UNITED STATES
DEPARTMENT OF THE INTERIOR
BUREAU OF LAND MANAGEMENT

CARLSBAD DISTRICT
OFFICEFORM APPROVED
OMB NO. 1004-0135
Expires: July 31, 2010**SUNDRY NOTICES AND REPORTS ON WELLS**
Do not use this form for proposals to drill or to re-enter an abandoned well. Use form 3160-3 (APD) for such proposals.

Devon Energy respectfully requests a sundry to use a multi-bowl wellhead on the Cotton Draw Unit 223H.

**Devon Energy Production Company, L.P.
Cotton Draw Unit 223H - API 30-015-43275
Section 12, T. 25 S., R 31 E., NMPM
Eddy County, New Mexico**

DEVON ENERGY
ARTESIA
S.E.N.M
13 3/8 X 9 5/8

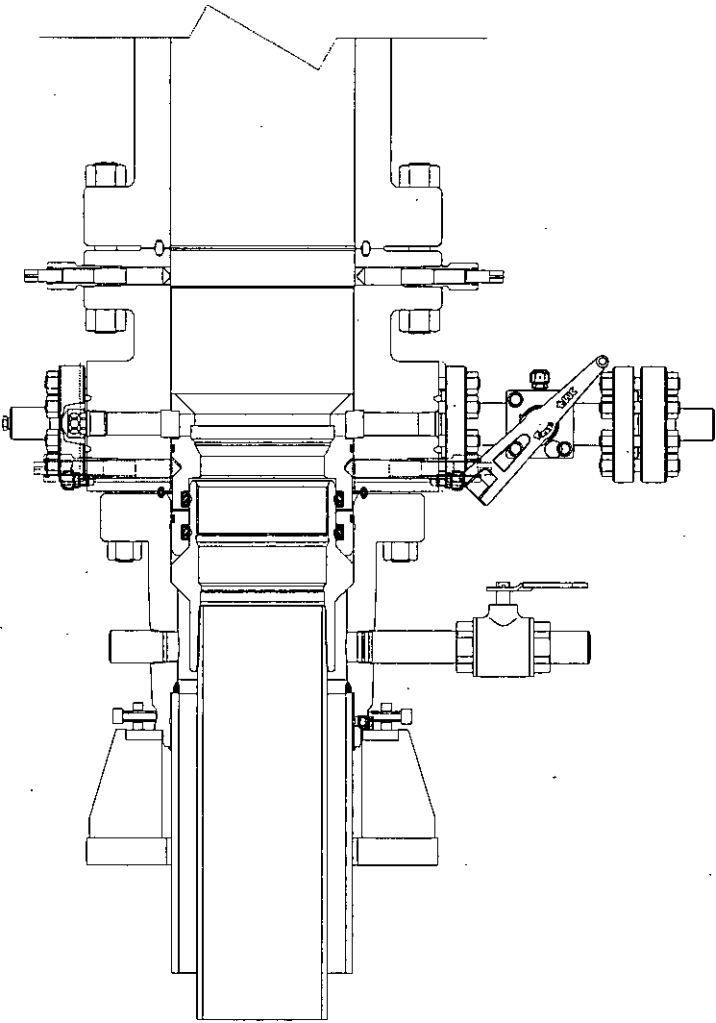
cementing intermediate casing. After installation of the pack-off, the pack-off and the lower flange will be tested to 3M, as shown on the attached schematic. Everything above the pack-off will not have been altered whatsoever from the initial nipple up. Therefore the BOP components will not be retested at that time.

? Devon will pressure test all seals above and below the mandrel (but still above the casing) to full working pressure rating.

? Devon will test the casing to 0.22 psi/ft or 1500 psi, whichever is greater, as per Onshore Order #2.

After running the 13-3/8" surface casing, a 13-5/8" BOP/BOPE system with a minimum rating of 3M will be installed on the multi-bowl wellhead system and will undergo a 250 psi low pressure test followed by a 3,000 psi high pressure test. The 3,000 psi high and 250 psi low test will cover testing requirements a maximum of 30 days, as per Onshore Order #2. If the well is not complete within 30 days of this BOP test, another full BOP test will be conducted, as per Onshore Order #2. After running the 9-5/8" intermediate casing with a mandrel hanger, the 13-5/8" BOP/BOPE system with a minimum rating of 3M will already be installed on the multi-bowl wellhead.

2. Operator has proposed a multi-bowl wellhead assembly. This assembly will only be tested when installed on the surface casing. Minimum working pressure of the blowout preventer (BOP) and related equipment (BOPE) required for drilling below the surface casing shoe shall be 3000(3M) psi.

- a. Wellhead shall be installed by manufacturer's representatives, submit documentation with subsequent sundry.
 - b. If the welding is performed by a third party, the manufacturer's representative shall monitor the temperature to verify that it does not exceed the maximum temperature of the seal.

- c. Manufacturer representative shall install the test plug for the initial BOP test.
 - d. Operator shall perform the intermediate casing integrity test to 70% of the casing burst. This will test the multi-bowl seals.

- e. If the cement does not circulate and one inch operations would have been possible with a standard wellhead, the well head shall be cut off, cementing operations performed and another wellhead installed.
